## NRC Request Q-6

## FCS Response

Figure 1 – Wetted areas of Trench 16 after infiltration event

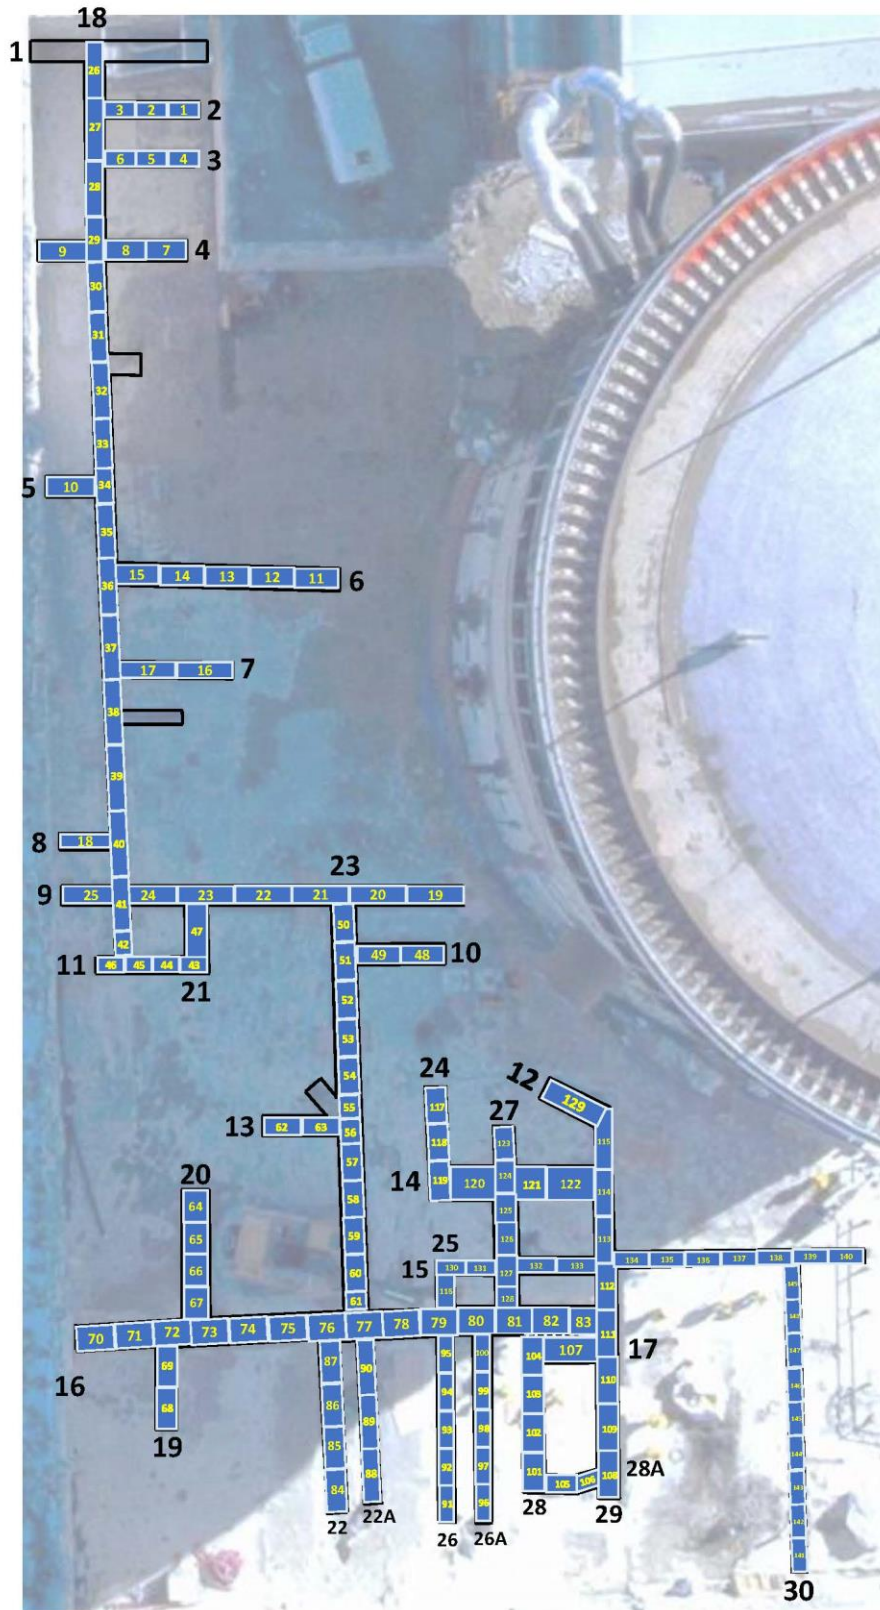
Provide support for release rates (i.e., cumulative release) from grout and cement so that staff can make a determination that dose criteria specified in 10 CFR 20.1402 is not underestimated. The support should consider: (i) the trenches are in the zone of a fluctuating water table, (ii) some amount of advective flow could occur in fractures and contact planes of different materials, (iii) downward migration both by diffusion and advection, and (iv) selections of literature inputs that do not lead to underestimates of dose. Alternatively, provide justification that the uncertainty in the input values is encompassed in the release rate.

Below the emplaced grout, removal of the embedded pipes led to fracturing of the cement in the basement of the building. This could lead to rapid flow through these fractures as the water table rose and fell. As contaminants are released they will travel downward through the fractures subject to chemical retardation effects during the drainage phase of the fluctuation.

After excavation of the trenches and prior to filling them with grout, water inflow was observed in the Auxiliary Building east trench area in March 2024 due to a rise in the water table. Inflow was not observed in the stressing gallery trenches. The inflow in the east trenches occurred over approximately a one-week period. Inflow was observed at several small locations in Trench 16 (Figure 1) and one location in Trench 14. Figure 2 shows the grid used to define trench locations, and Table 1 lists the area inflow was observed and the area over which inflow occurred. The total trench area in the east trench zone is 325 m<sup>2</sup>.

After capping the inflow was greatly reduced limiting inflow to 15 – 20 gallons.
